July 16, 2018

RE: Lot 26 Block 6 Volcano Cliffs Unit 22 SAD 228 6209 Papagayo NW **Grading and Drainage Plan Engineers Stamp Date 7/11/18 (D10D003B26)** Pad Certification Date 2/9/18

DRAINAGE AND TRANSPORTATION INFORMATION SHEET (REV 6/2018)

ENGINEER'S SEAL 6209 PAPAGAYO ROAD NW DRAWN BY WCWJ 7-10-18 GRADING AND DRAINAGE PLAN 21800-LAYOUT-9-22-1 SHEET # Rio Grande Engineering ___ 7/11/18

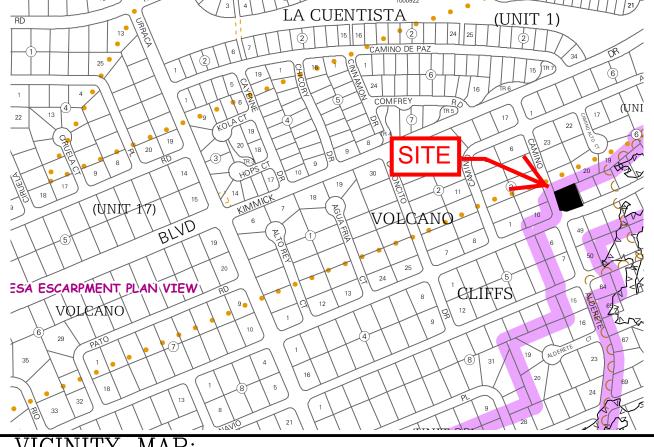
Based upon the information provided in your submittal received 7/12/18, this plan is approved for Building Permit, Pool Removed.

Please inform the builder/owner to attach a copy of this approved plan and this letter to the construction sets in the permitting process prior to sign-off by Hydrology. Reiterate to the Owner/Contractor that a separate permit for a garden/retaining wall must be obtained, with the approved G&D plan dated 7/6/18.

Prior to Certificate of Occupancy release, Engineer Certification per the DPM checklist of this plan will be required.
